MPL2013-00024 SUB2013-00029 ITEM # 3

- Specific Parcel Master Plan (SPMP) approval for Lake Nona Central Parcel 12 residential development comprised of 144 single family lots.
- Request for Major Subdivision Plat to create the preliminary plat for Lake Nona Central Parcel 12.

Updated: August 16, 2013

DRI MAP H—PARCEL 14 PROPOSED SCHOOL SITE

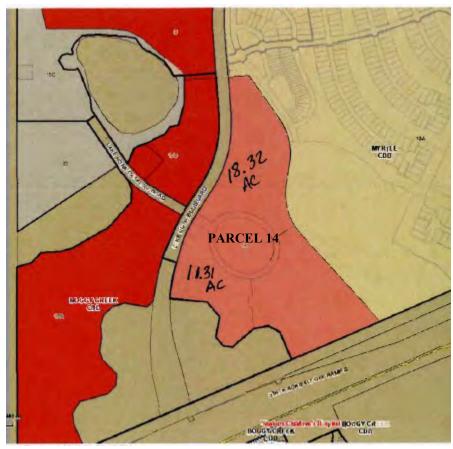
The adopted Lake Nona DRI Map H 8.2 depicts Parcel 12 in two parts. Parcel 12a is designated as "Residential Neighborhood" and Parcel 12b is designated as "Elementary School". The SPMP proposes housing units on the "Elementary School" site which is inconsistent with the DRI. Staff originally provided as a condition of approval that "Prior to the approval of Phase 2 and 3 of the SPMP, the applicant shall submit a DRI and PD amendment to change the "Elementary School" to "Residential Neighborhood" for review and approval by the Municipal Planning Board."

The exhibits associated with the 2009 PD/DRI amendment show acreage being added to Parcel 14 from Parcel 13A to create a 15-acre civic site. The Parcel 13A area has since been developed with housing, however more than 15 acres remain undeveloped in Parcel 14. This means that a civic site is still possible within Parcel 14, but in a different configuration than was shown in 2009. Staff has informed OCPS of this change and has requested comments. The DRI and associated agreements with OCPS do not require either site to be donated for use as a public school. Therefore, the site can be used for any number of civic uses such as a library, private school or park. This change ensures that the overall PD/DRI retain the same acreage of civic uses, but does not guarantee that a public school will be located on the site. However, the applicant has indicated that they are supportive of a public school on Parcel 14 and will continue to work with OCPS in that regard.

In 2009, there was an approval by the Municipal Planning Board of a DRI and PD amendment for the relocation of the school site on Parcel 12 (Case #DRI2008-00002 & Case #ZON2008-00039), but it was not approved by City Council through an amendment to the DRI Development Order or PD ordinance. In order for the DRI and PD to be consistent with this SPMP proposal, the applicant shall prepare a PD ordinance and DRI DO for review by City Council.

LAKE NONA CENTRAL PARCEL 12 DEVELOPMENT PLAN/PRELIMINARY PLAT

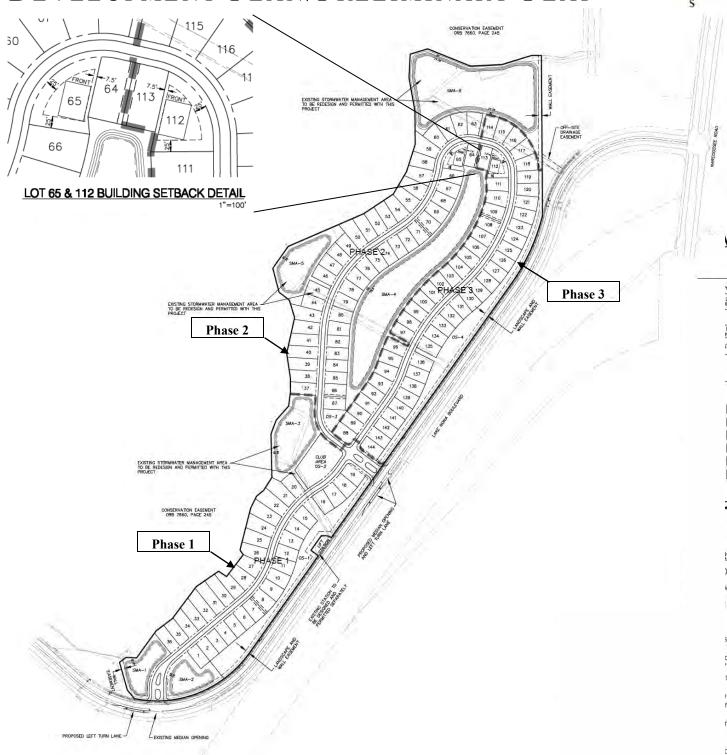
This SPMP and preliminary plat depicts 144 front-loaded single family lots that are 70 feet x 125 feet. The project also includes neighborhood greens and a club house for residents. The applicant is also proposing that this community be gated. It will developed in three (3) phases with 36 units in the first phase, 51 units in the second phase, and 57 units in the third phase.

The R-1A zoning standard requires a minimum lot width of 70 feet and a minimum lot depth of 110 feet. The SPMP depicts a single family large lot with a minimum lot width of 70 feet and a minimum lot depth of 125 feet, which meets the lot size requirement.

The maximum ISR permitted is 0.55 according to the R-1A zoning standards. However, the development plan depicts an ISR of 0.70 which exceeds the maximum ISR of 0.55. The applicant is requesting an alternative standard of 0.70 and has provided a letter from the project engineer stating that the stormwater system is being designed to handle this amount of impervious surface.

The required setbacks for the R-1A zoning district is depicted in Table 3 below. The proposed SPMP meets the setback requirements.

The applicant is requesting an alternative standard of 0.70. The ISR of 0.70 is approved as long as it can be demonstrated that the stormwater system will be designed to handle the increased amount of impervious surface.
